ADDENDUM NO. 1

Plans & Specifications for: Elsie Turner Field & Graverson Playground, Waltham, MA

In accordance with documents prepared by: Carolyn Cooney & Associates

Project:
**CITY OF WALTHAM
 ELSE TURNER FIELD
 425 TRAFLEO ROAD
 WALTHAM, MA 02452**

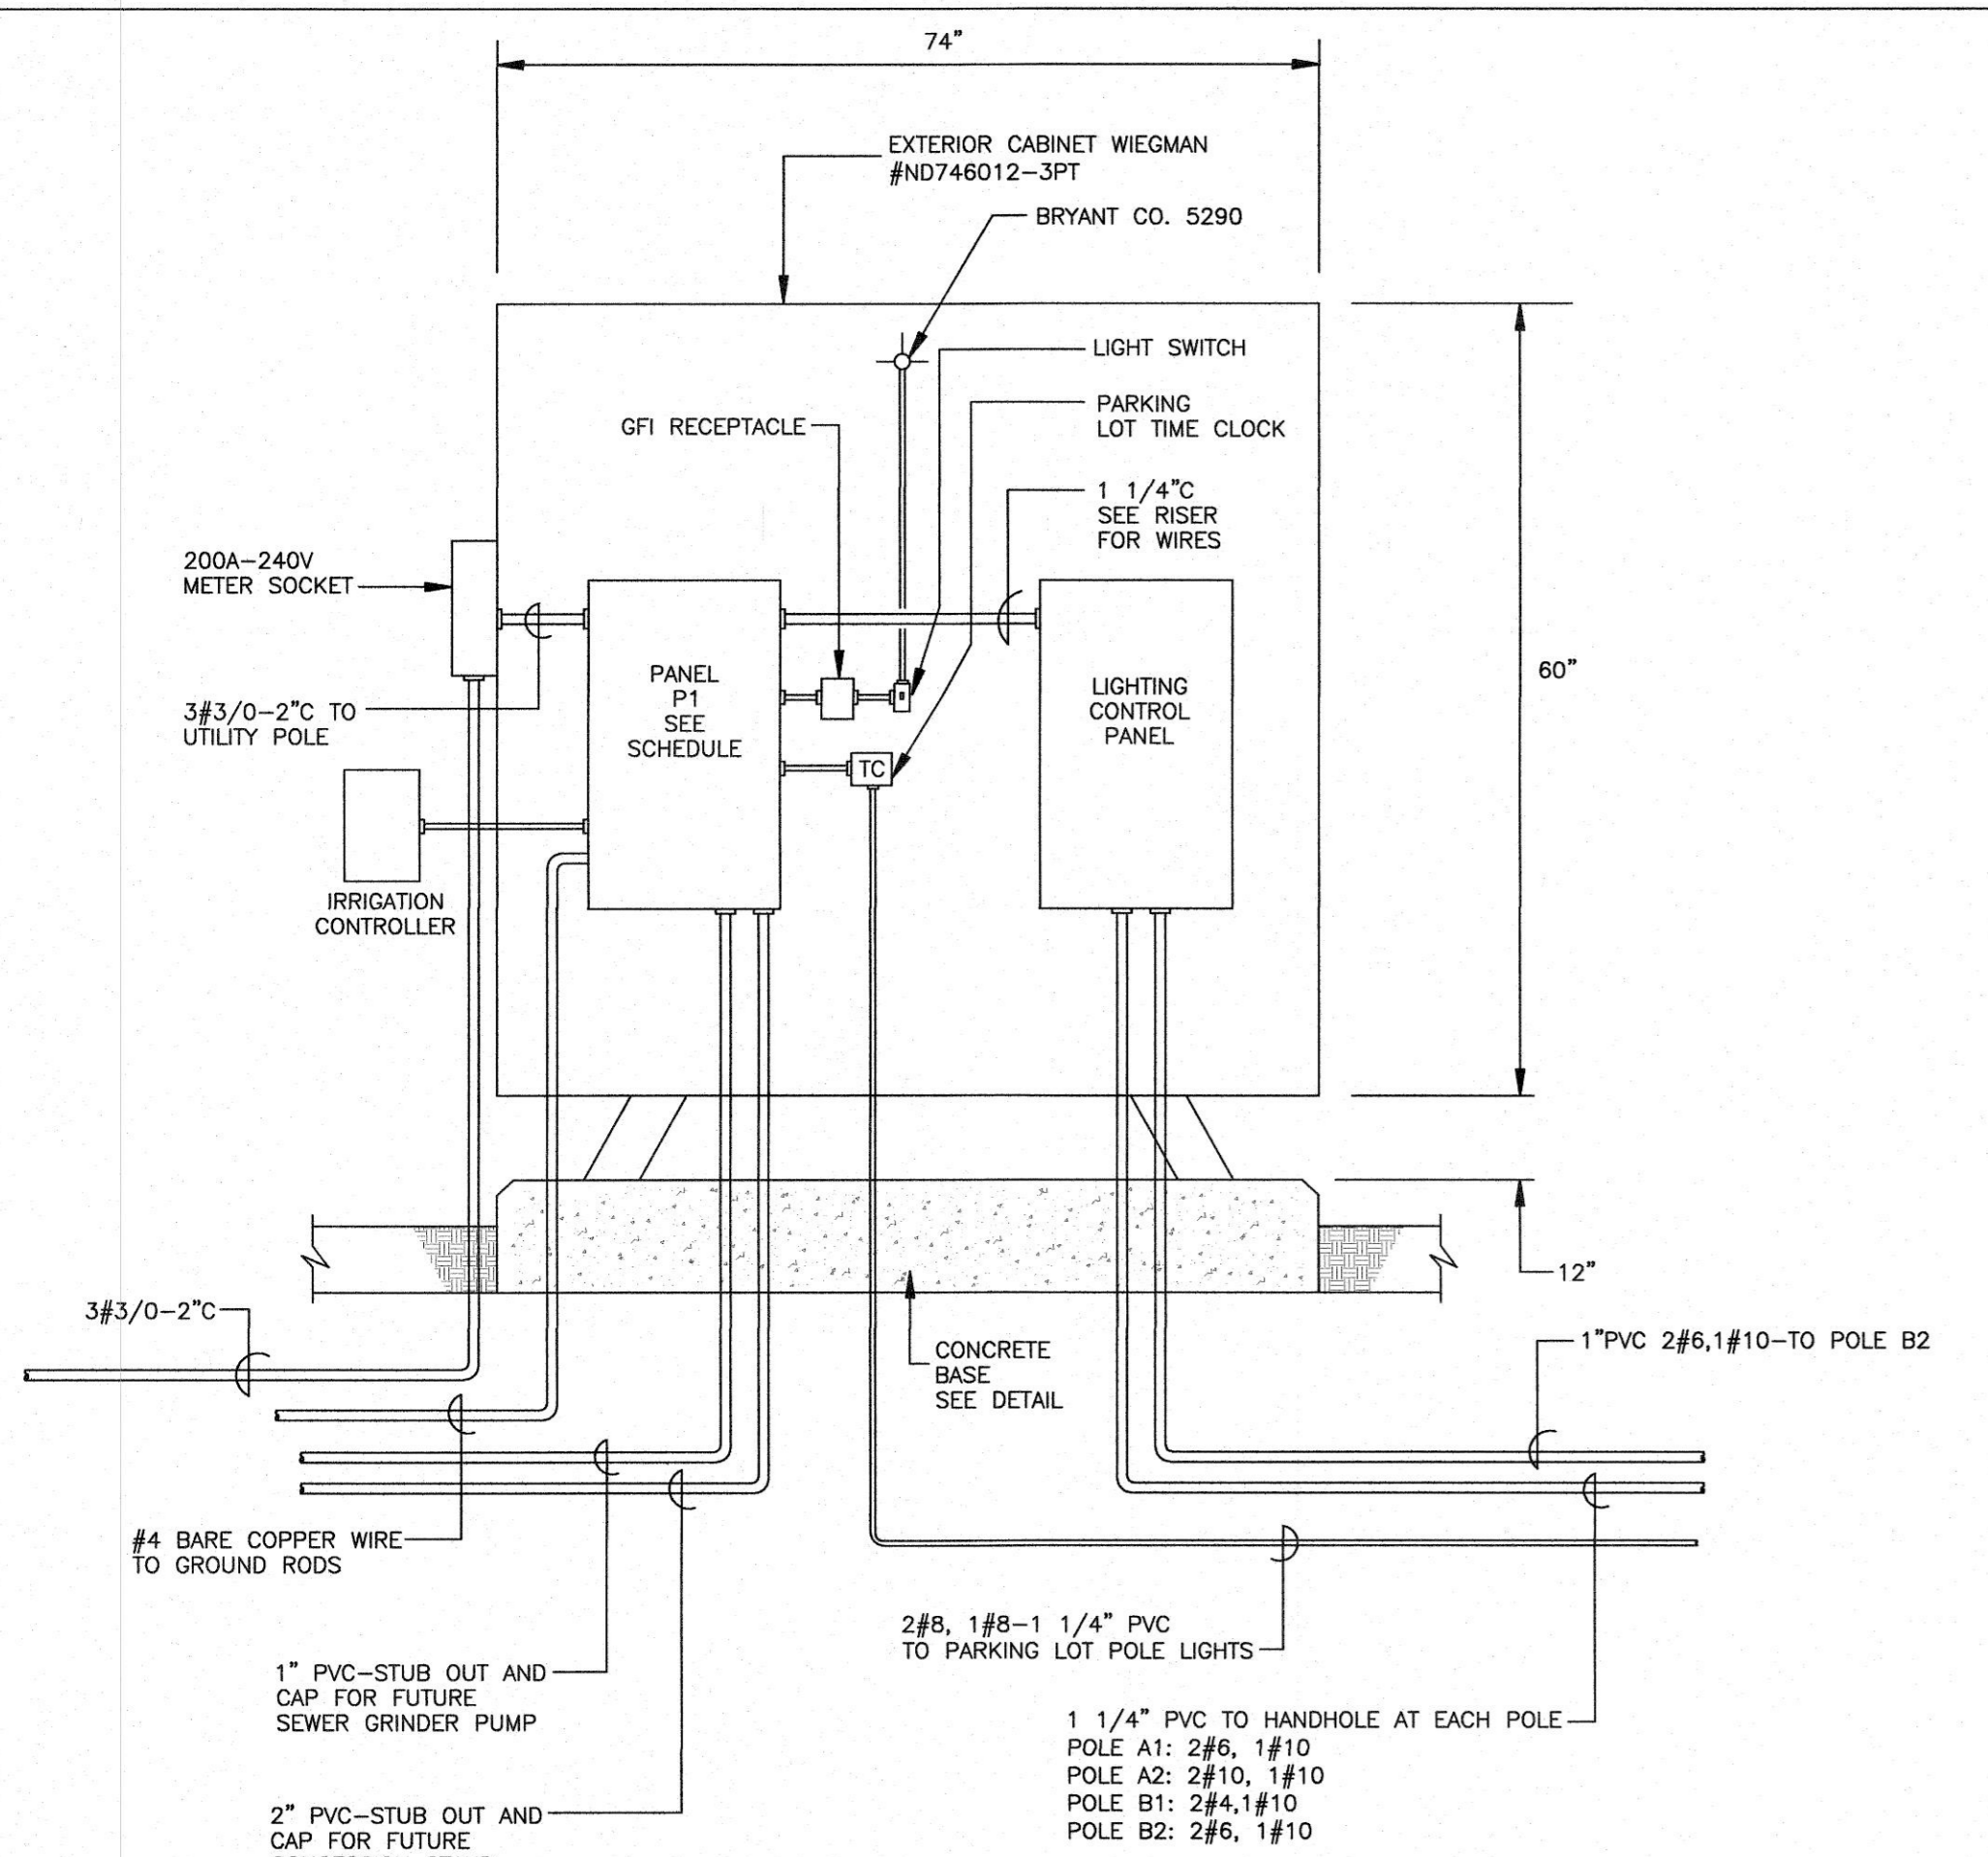
- ITEM NO. 24** *Elsie Turner Field: Replace Drawing L.614 with new drawing L.614 attached.
Revision is to delete a portion of chain link fencing at dugouts.*
- ITEM NO. 25** *Elsie Turner Field: Add new drawing L.624, attached.*
- ITEM NO. 26** *Elsie Turner Field: Replace Drawing ES.1A with new Drawing ES.1A attached.
Revision is to number of light fixtures.*
- ITEM NO. 27** *Elsie Turner Field: Replace Drawing ES.2 with new Drawing ES.2 attached.
Revision is to number of light fixtures, and correction to Control Cabinet Detail connections.*
